WATERSTONE, Fil. No. 4-Site Plan

Technical Correction-Response to Comments

Re: Waterstone Filing No. 4
Site Plan Comments and Technical Corrections
Aurora, Colorado

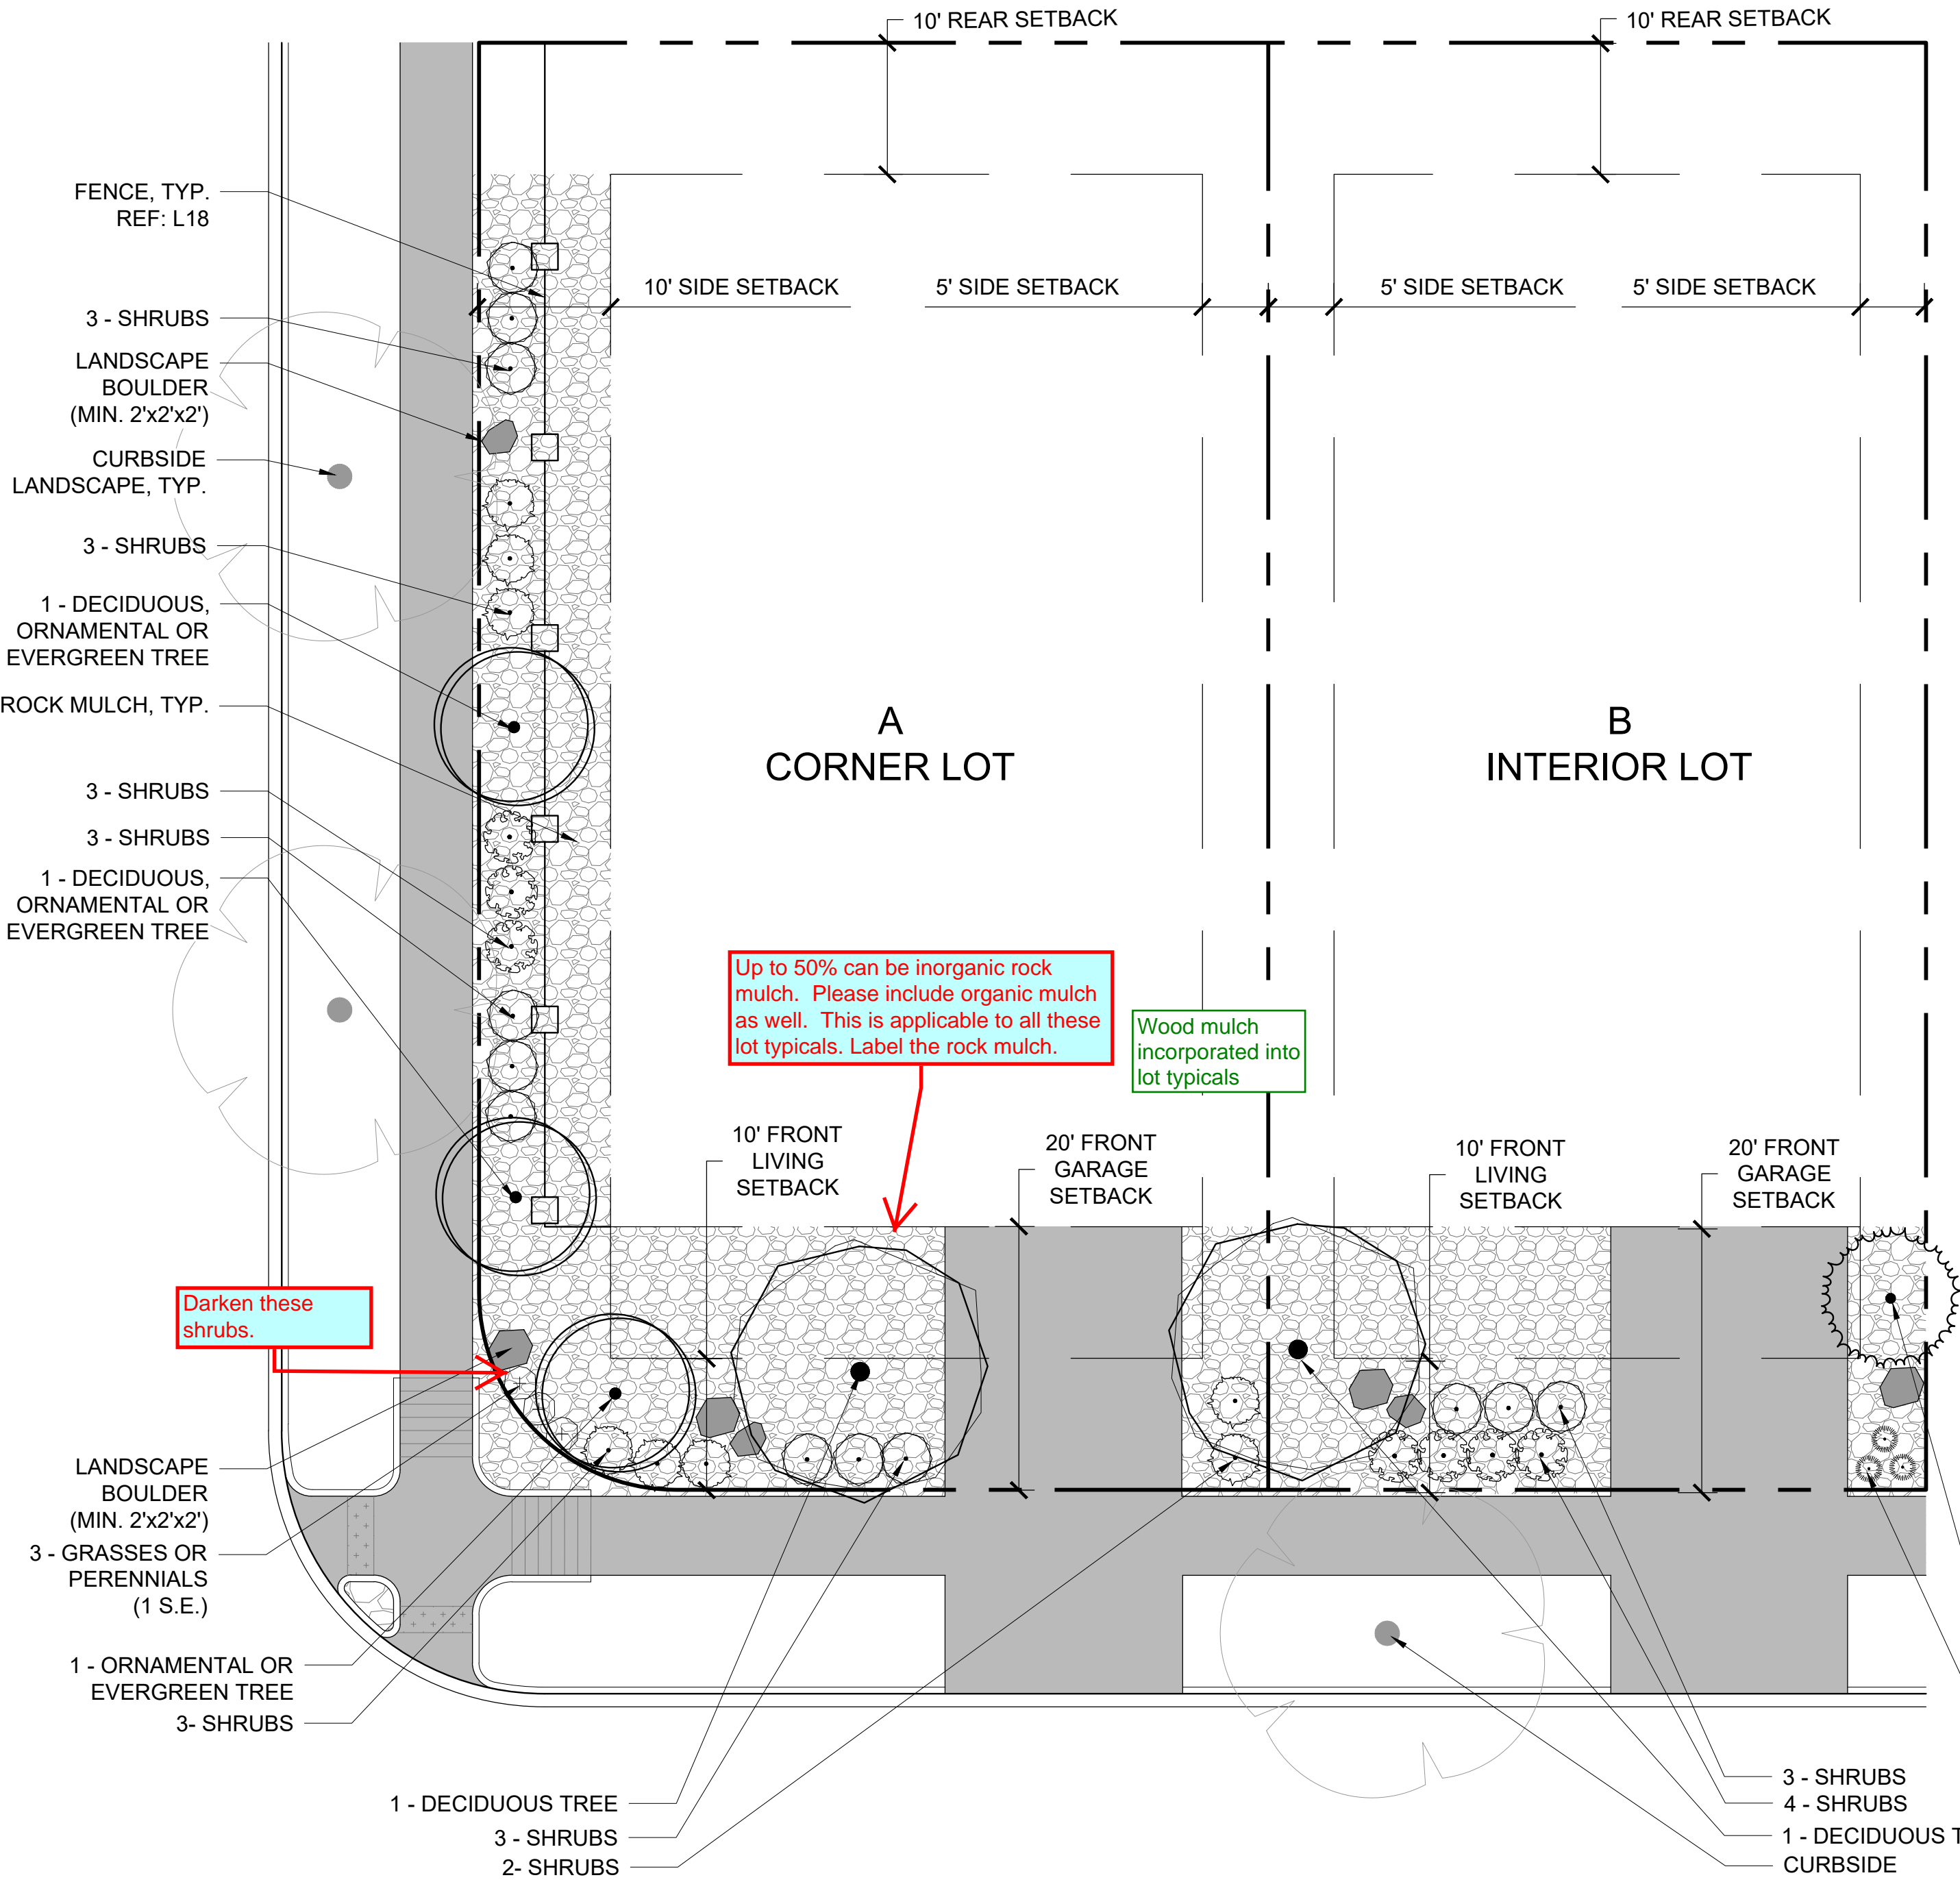
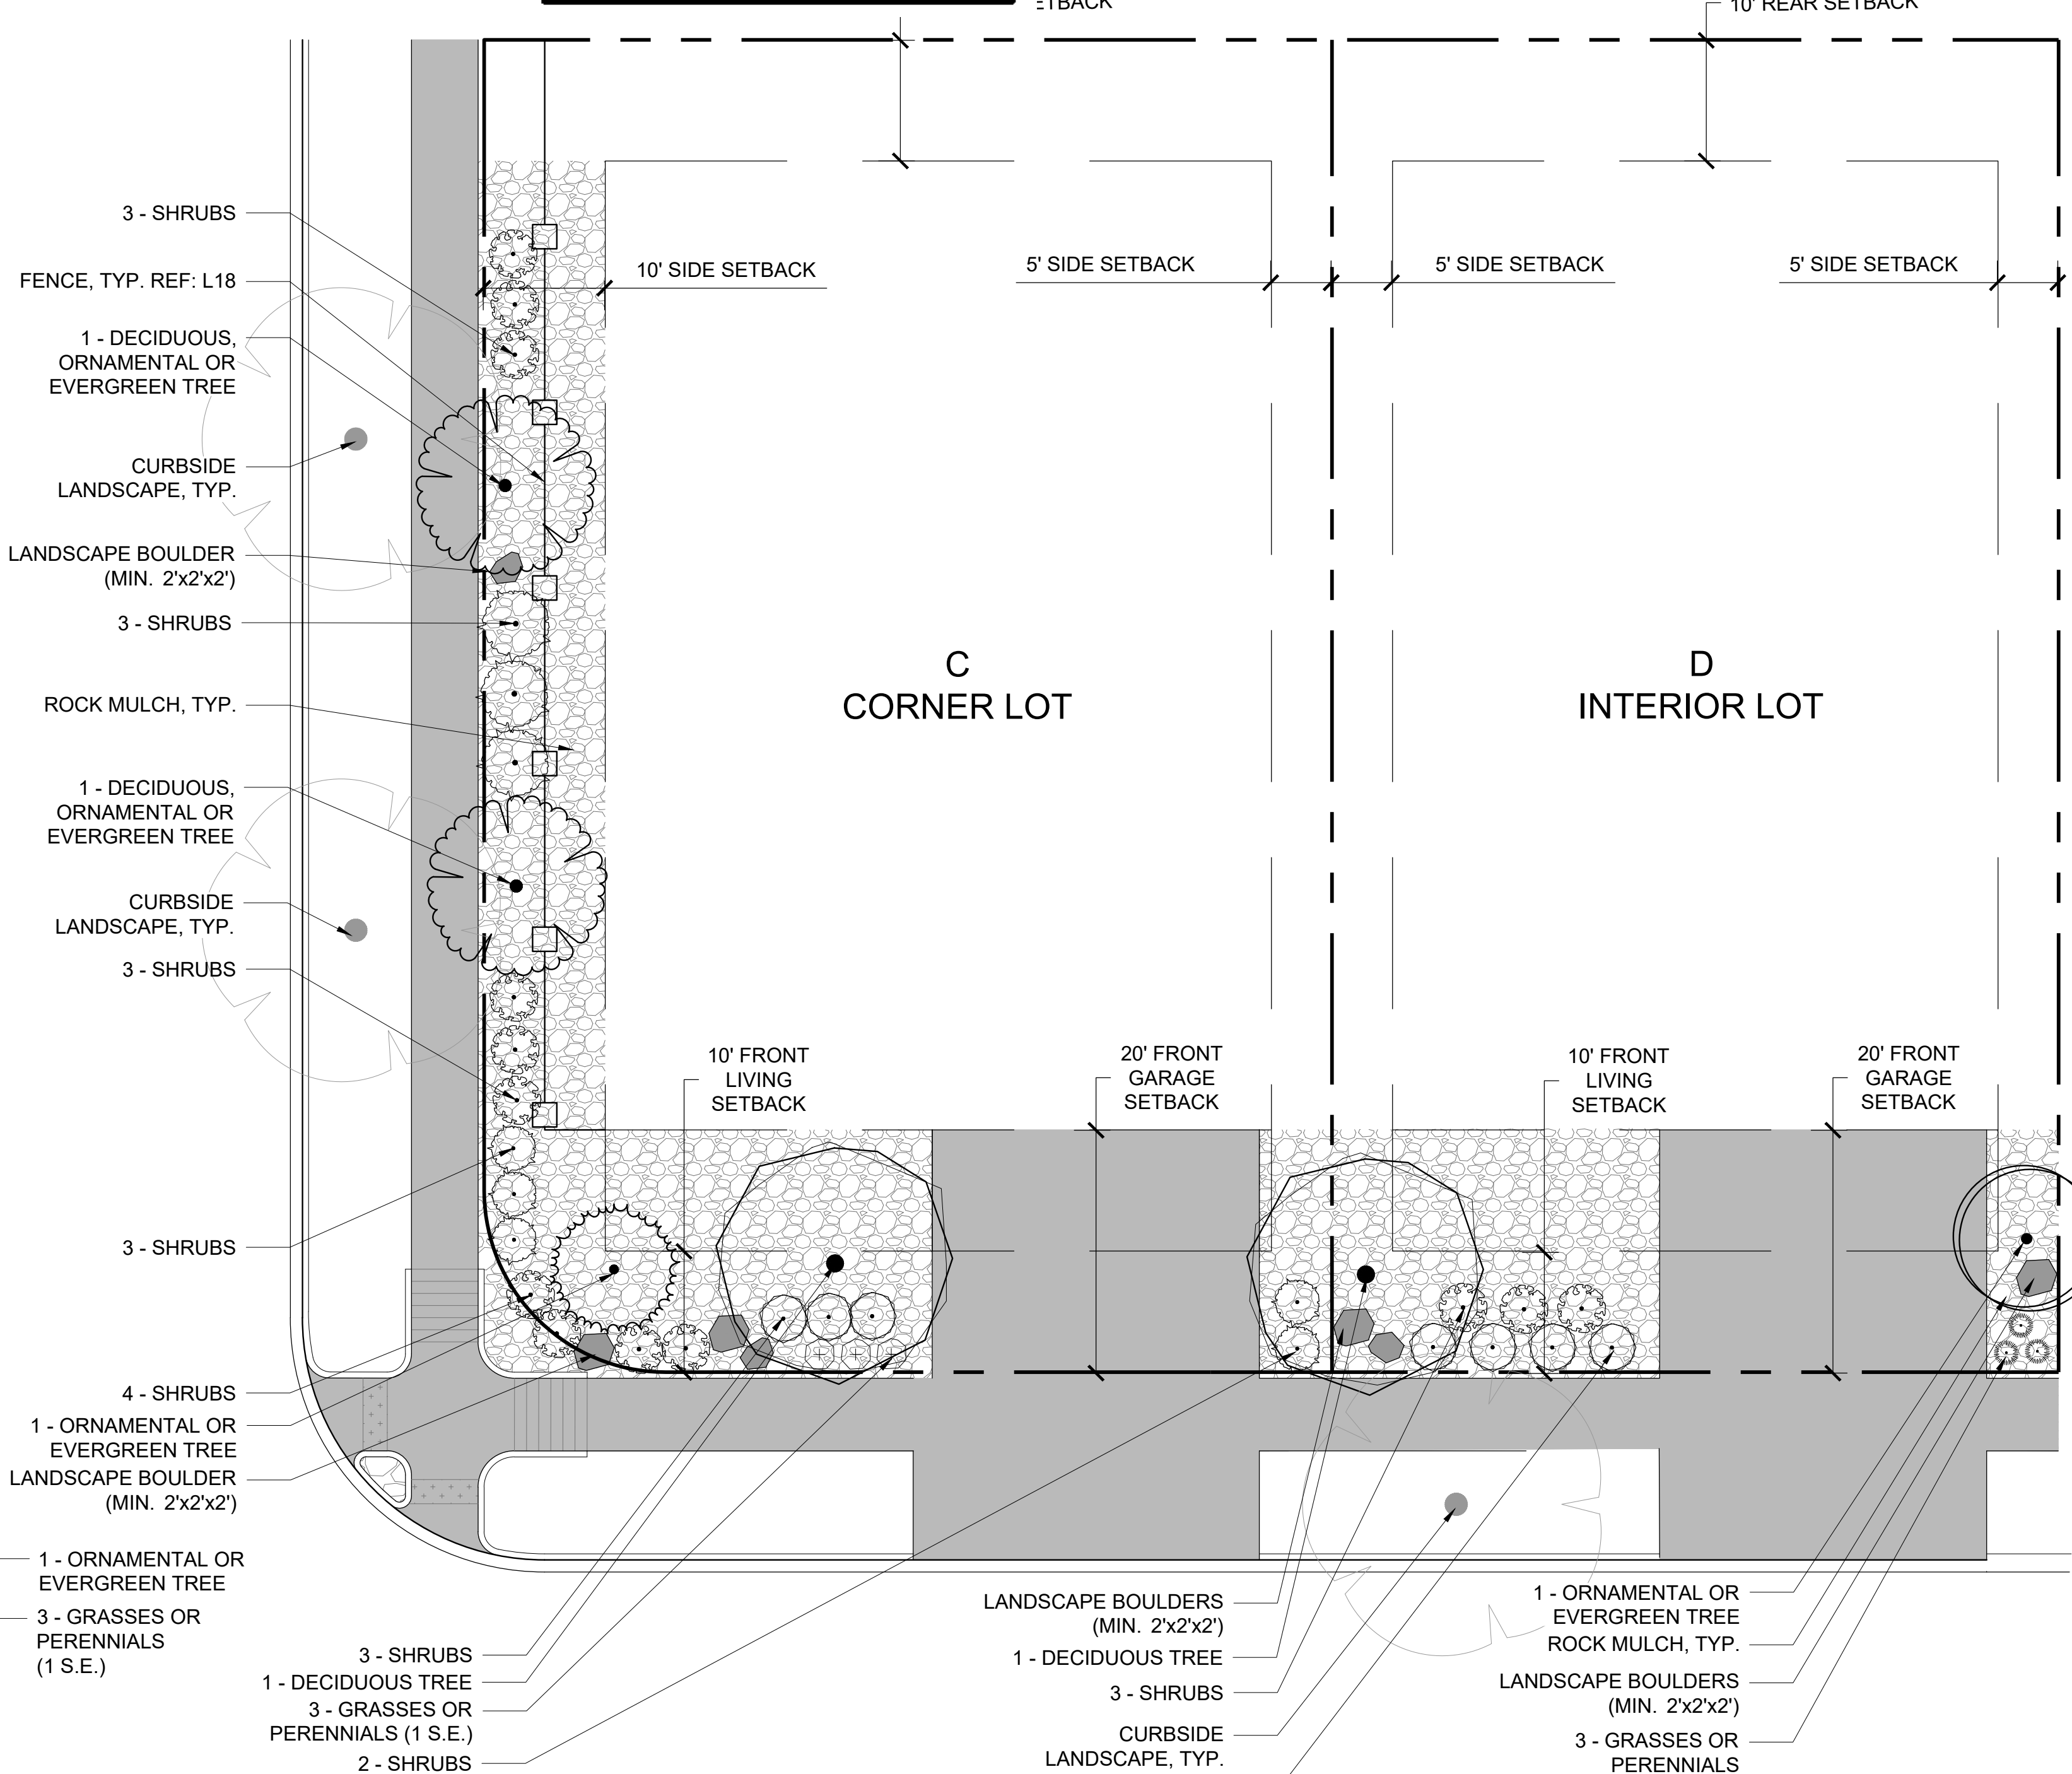
This sheet needs to be moved either before or just after the landscape plan enlargements.

Include any easements and the approximate location of the utilities i.e. water and sanitary sewer lines to each lot. See image to the right this sheet.

SHEET ORDER IS REVISED
